Please upload to BE/101/21/HH as Planning Correspondence – Amended Plans email

From: Glenn Travers <glenn.travers@arun.gov.uk>
Sent: 30 November 2021 17:33
To: Richard Sherman <Richard.Sherman@arun.gov.uk>
Subject: Re: BE/101/21/HH - 3 Homing Gardens, Bersted

We are looking over your application for 'Replace metal framed/wood panel workshop in rear with brick-built workshop (This application may affect the character and appearance of the North Bersted Conservation Area) at the above address.

Existing Roof Plan

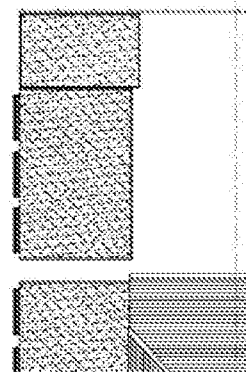
Also please can you re-submit a new roof plan as the one you have submitted cuts off the bottom section as below:

Please find attached as requested

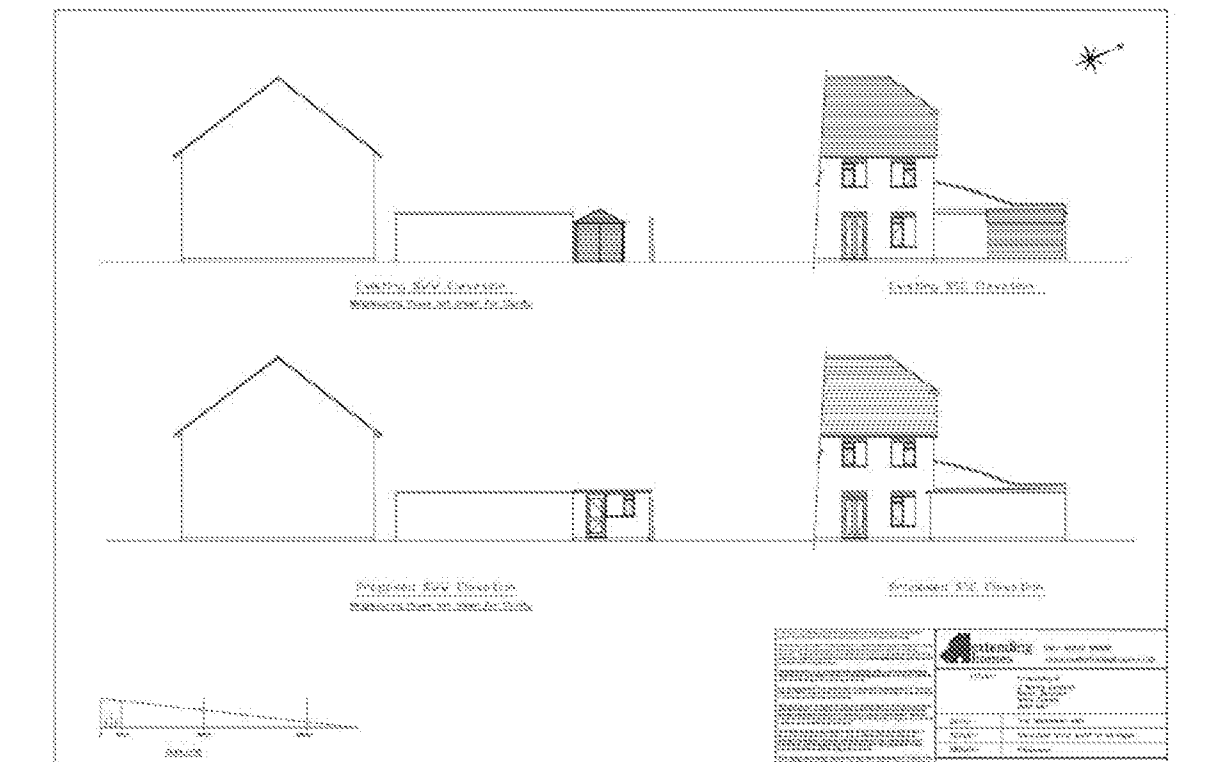
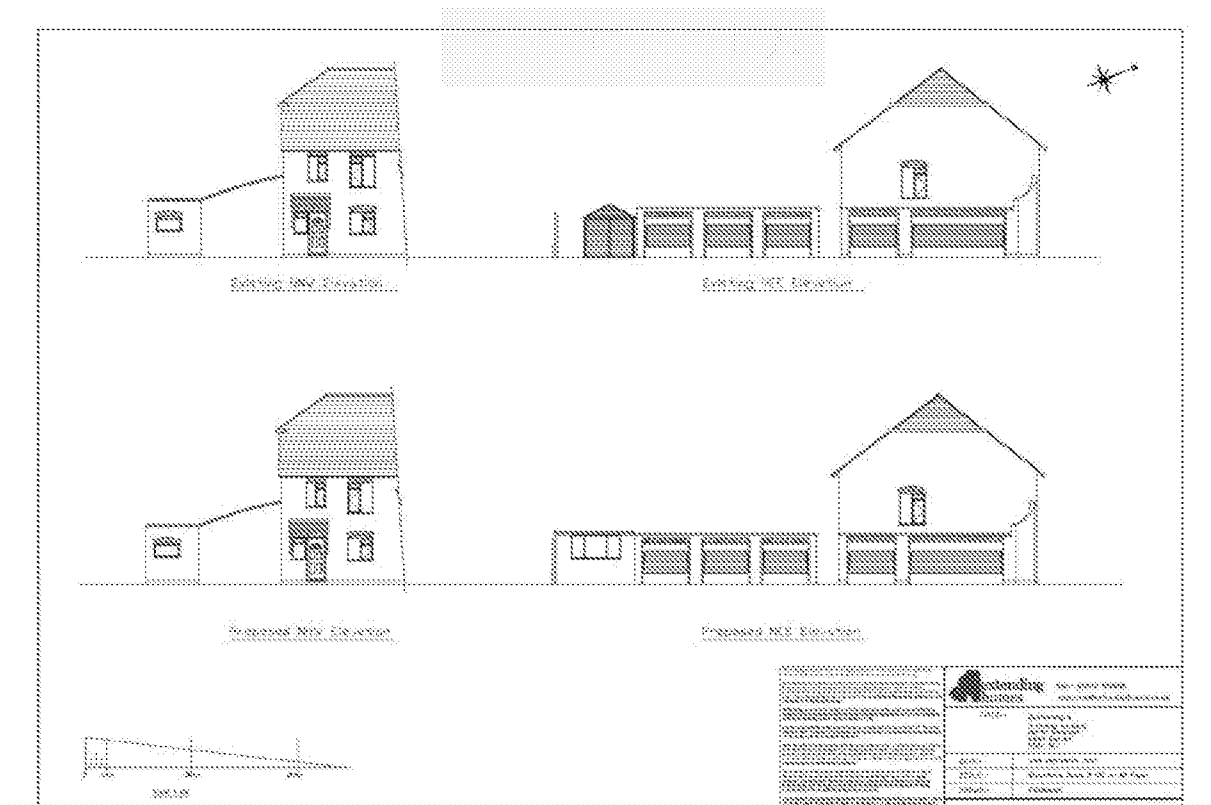
However on the Proposed Elevations plans you have submitted, they have been labelled incorrectly as 'Existing and Proposed NEE' and 'SWW' Please see snapshot below:

Therefore please can you amend these and resubmit these plans to me as they are supposed to be NNE and SSW?

Attached are new PDF's. 1B, 2B and 3A. Responding to No. 7s comment about linking to his wall, I have revised to show totally separate workshop.
